REV.	DATE	DCN #	DRAWING TREE #
01	27 JAN 04	MPL / CIT	
02	30 AUG 04	CIT REMOVED HOLES FOR V-GROOVED CLAMPS

SYSTEM
ADVANCED LIGO

PART NAME
WIRE BREAK OFF

SIZE DWG. NO.
A D040045

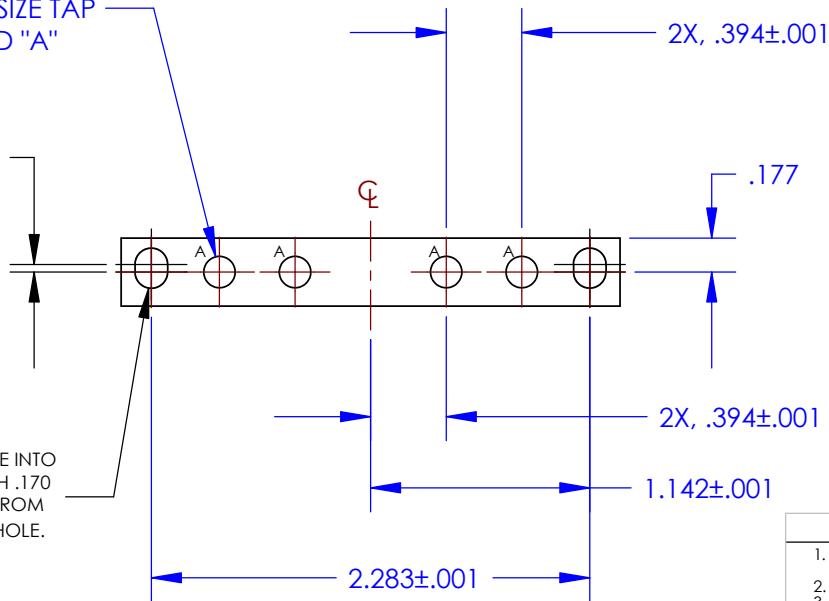
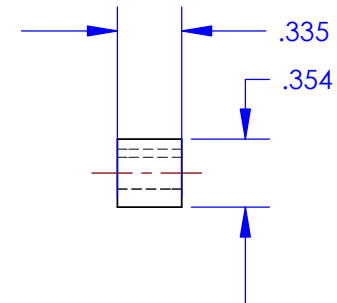
ADD MARK ON CENTRE LINE ON BOTH SIDES.

MAKE HOLE INTO
SLOT WIDTH .170
1mm UP FROM
EXISTING HOLE.
